#### **Addendum 140 – UN Regulation No. 141**

#### **Revision 1 – Amendment 2**

Supplement 2 to the 01 series of amendments – Date of entry into force: 4 January 2023

#### **Uniform provisions concerning the approval of vehicles with regard to their Tyre Pressure Monitoring Systems (TPMS)**

“Figure 1  
 Refilling check

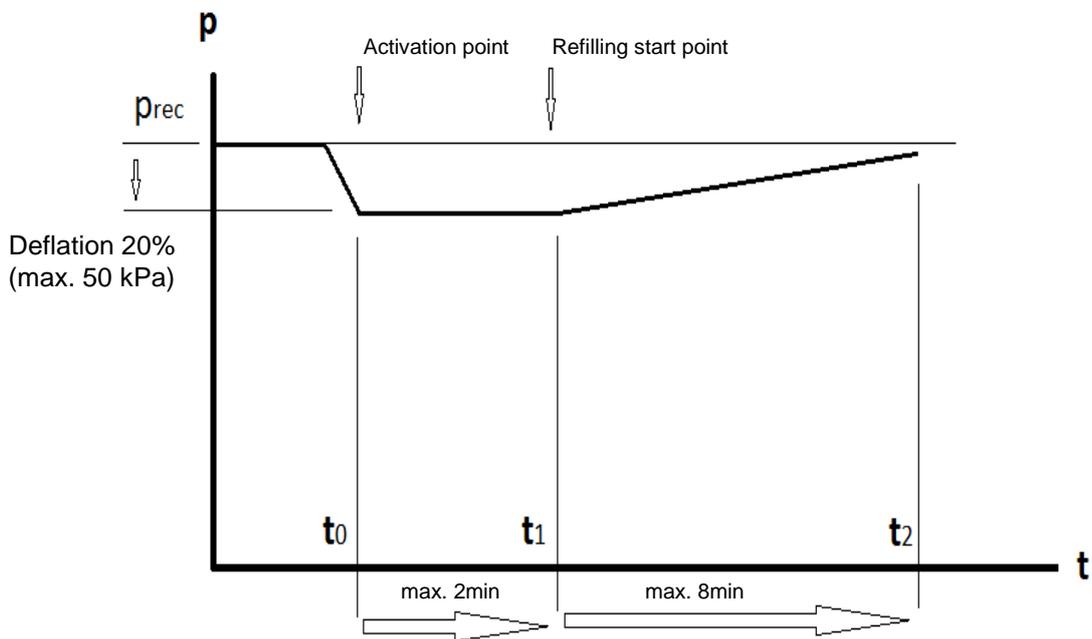
*Figure 1, amend to read:*

“2.5.1. Check refilling according to Figure 1

Check that within 2 minutes, when the system is operational, the TPRS/ CTIS starts refilling and at least after 2 minutes the low tyre pressure tell-tale, as described in paragraph 5.5. of the Regulation, is “On”.

Refill process shall be completed within 8 min after the refill process has started and the low tyre pressure tell-tale, as described in paragraph 5.5. of the Regulation, is “Off” as soon as the refilling process is completed.

After the refilling process has been completed, check that the tyre pressure is in a range of +/- 5% of manufacturers recommended cold inflation pressure  $P_{rec}$ .”

“Figure 2  
 Checking system malfunction warning functionality.

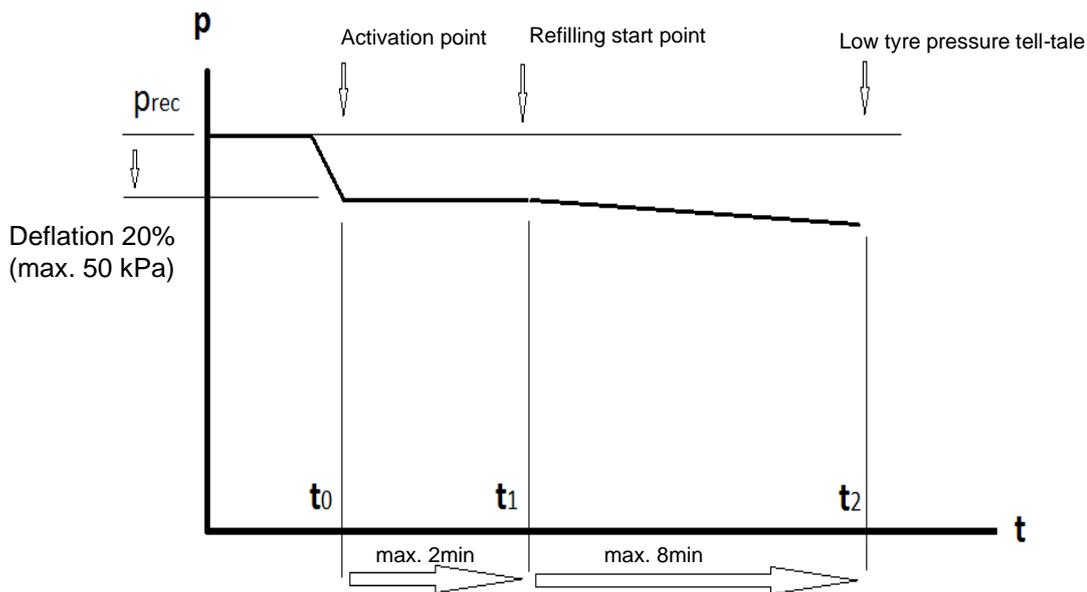
Figure 2, amend to read:

“2.5.2. Check refilling according to Figure 2

Check that within 2 minutes when the system is operational the TPRS/ CTIS starts refilling and at least after 2 minutes the low tyre pressure tell-tale, as described in paragraph 5.5. of the regulation, is “On”.

Refill process shall not be completed within 8 min after the refill process has started and the low tyre pressure tell-tale, as described in paragraph 5.5. of the regulation, is “ON” after at least 2 minutes of refilling time.

The deflation rate during the test must be higher than the refilling rate.”

**Arrangement of device under test and vehicle simulator where TPMS/ TPRS/ CTIS functionality is provided by ECU connected via ISO 11898-1:2015 and 11898-2:2016 interface**

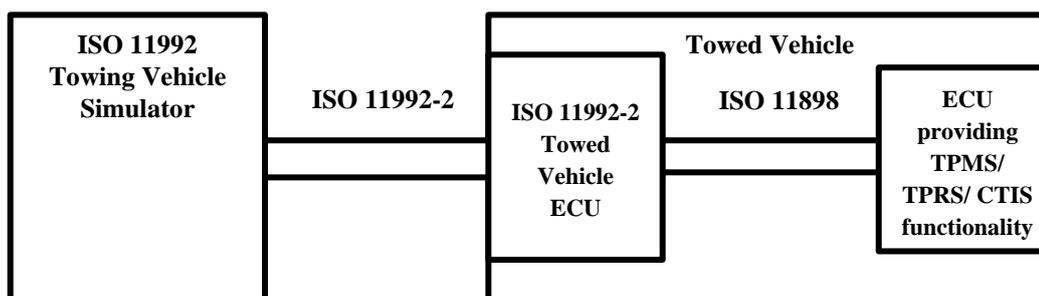
*Figure 1*, amend to read:

**Arrangement of device under test and vehicle simulator where TPMS/ TPRS/ CTIS functionality is provided by ECU connected to towing vehicle**

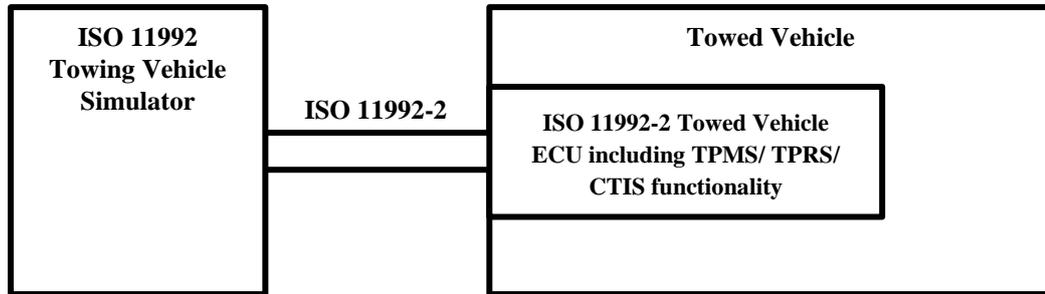
Figure 2, amend to read:
